ADDENDUM NO. 1

TOWN OF DRUMHELLER 2022 Utility Upgrades

Page 1 of 1
Engineer: MPE Engineering Ltd.	Date: August 16 th , 2022
	File: 2450-057-00

Drawing C1.0 – Site Plan Drawing C1.2 – Site Plan - Construction Phasing Drawing C1.3 – Site Plan – Surface Restoration Drawing C2.0 – Connection Details 1 of 2

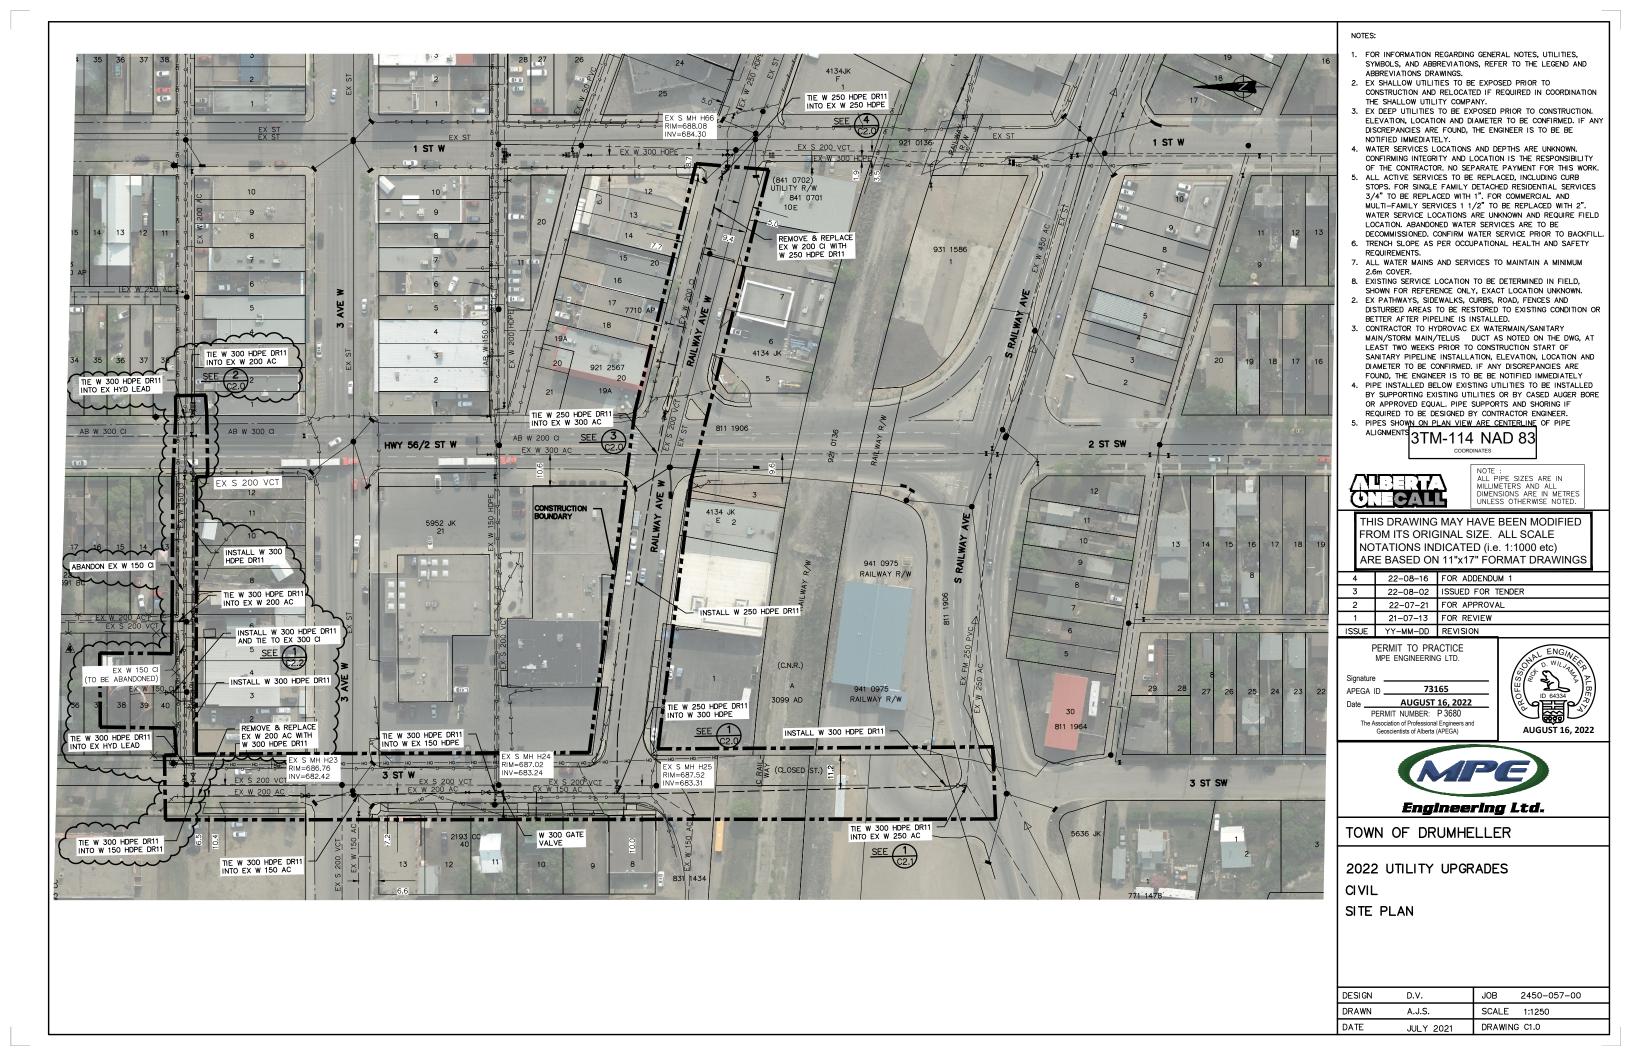
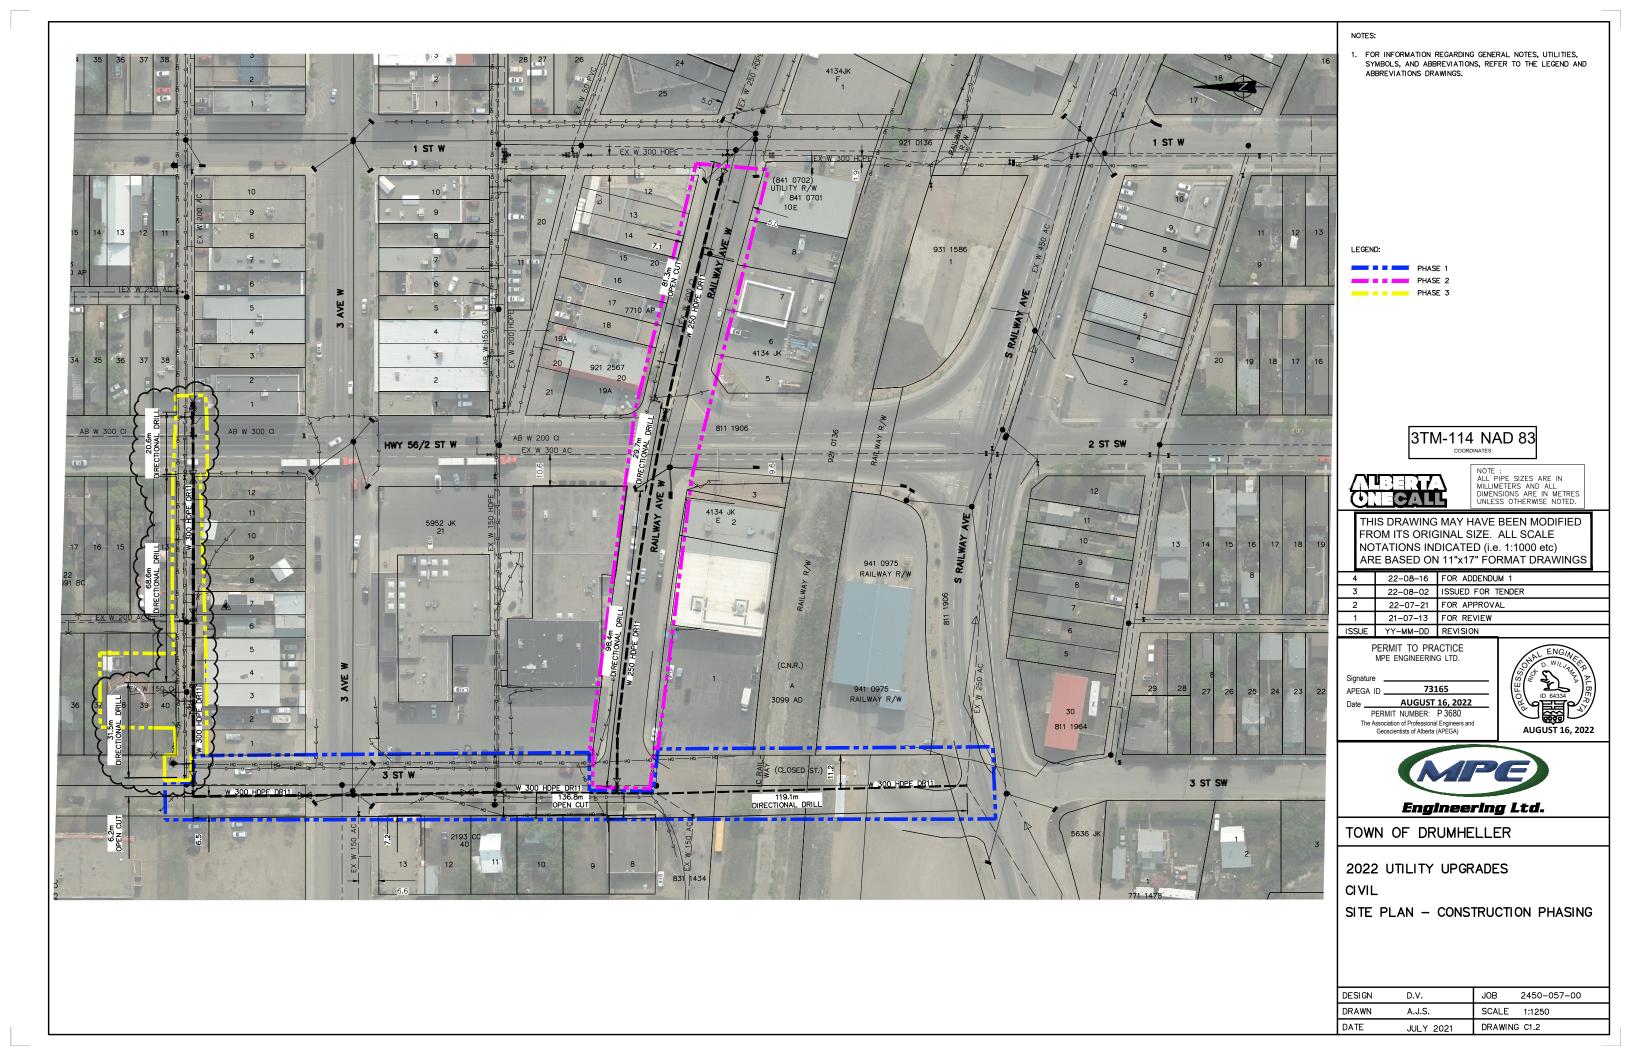
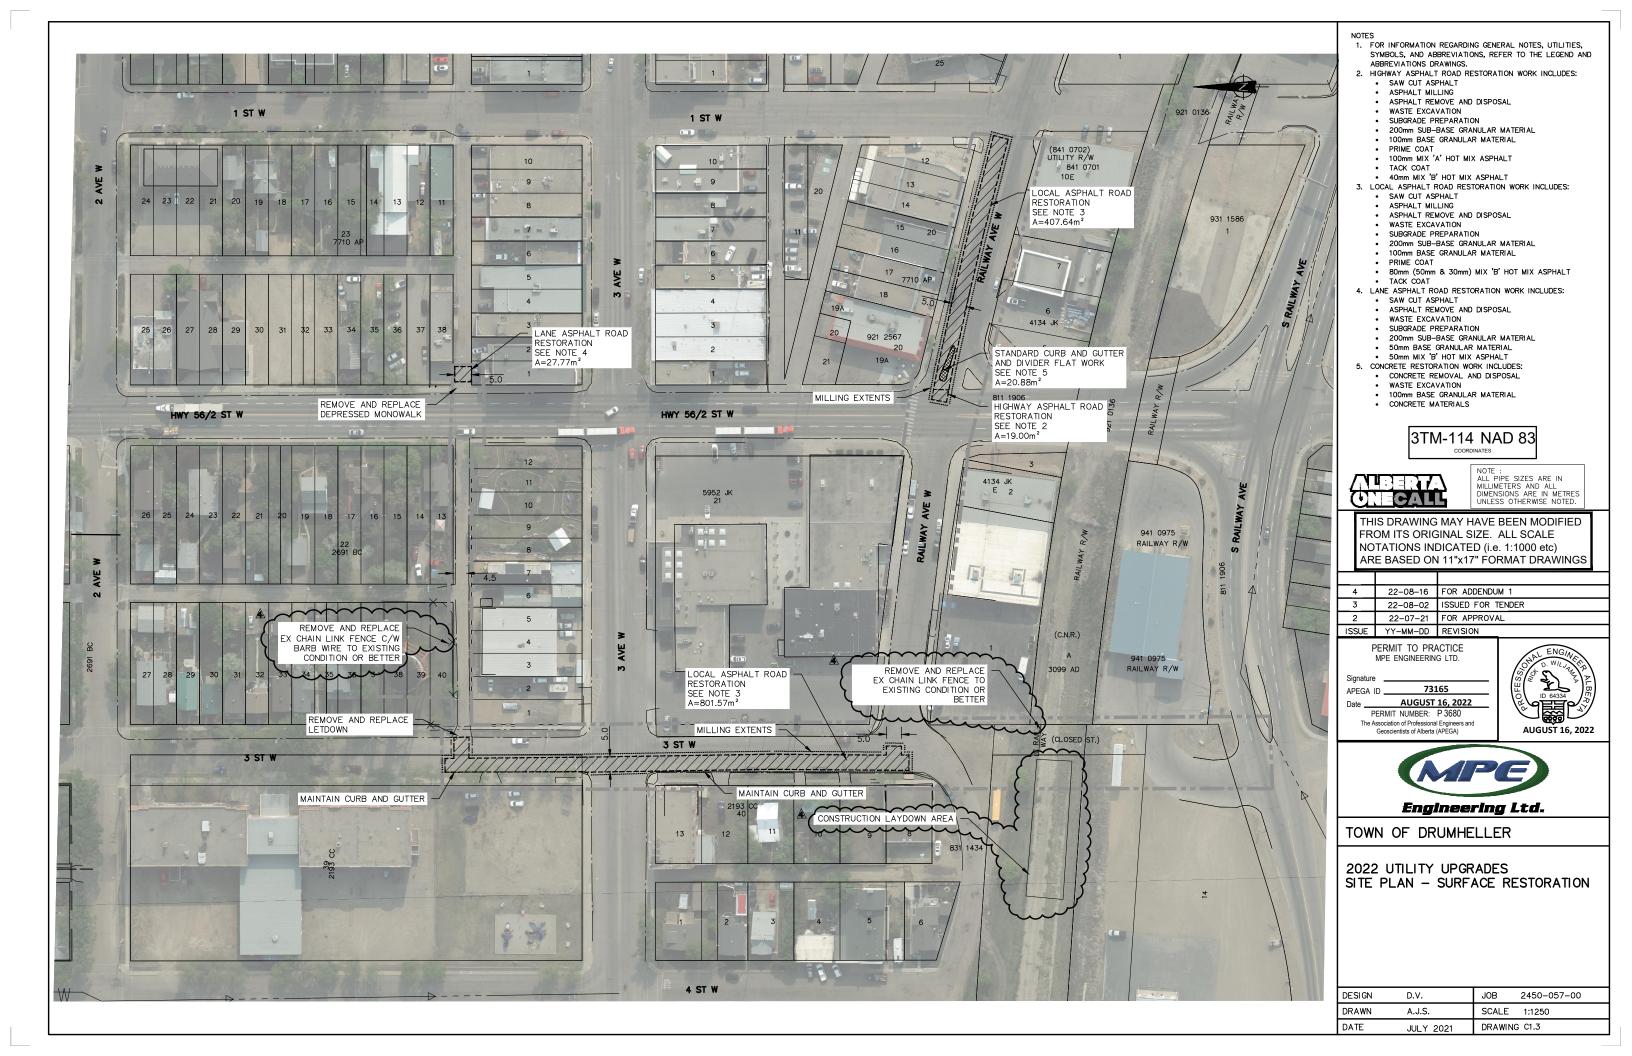
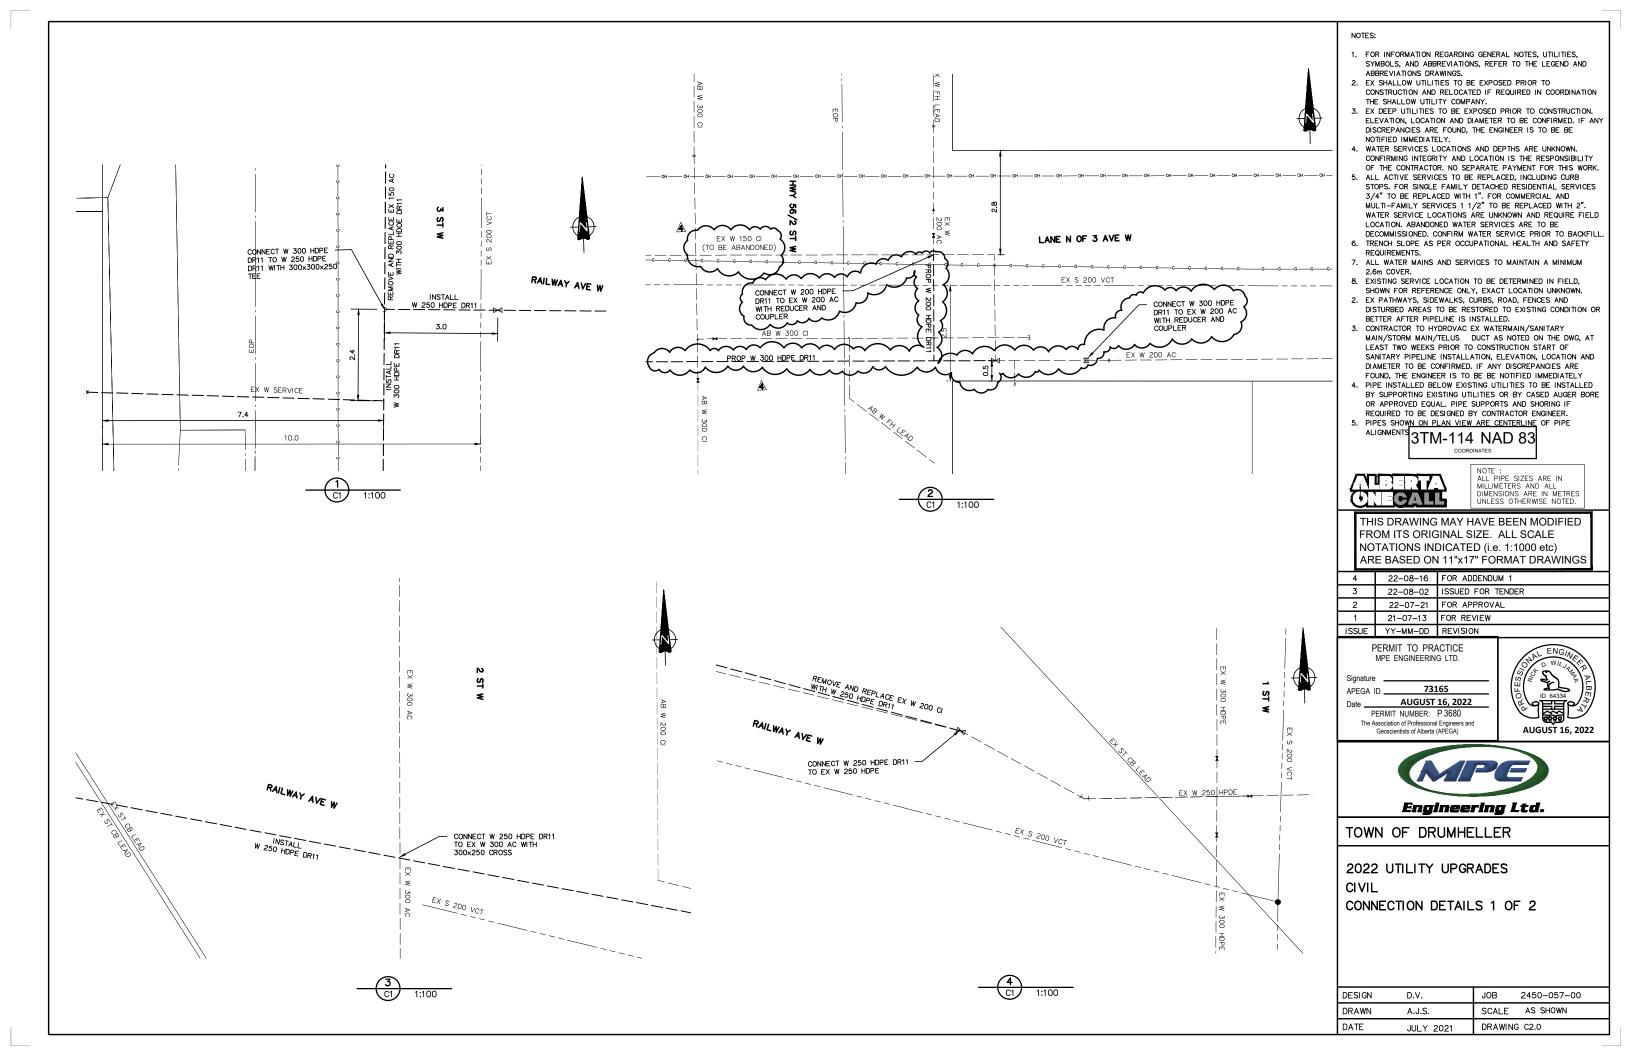
Drawing C1.0 – Site Plan Drawing C1.2 – Site Plan - Construction Phasing Drawing C1.3 – Site Plan – Surface Restoration Drawing C2.0 – Connection Details 1 of 2
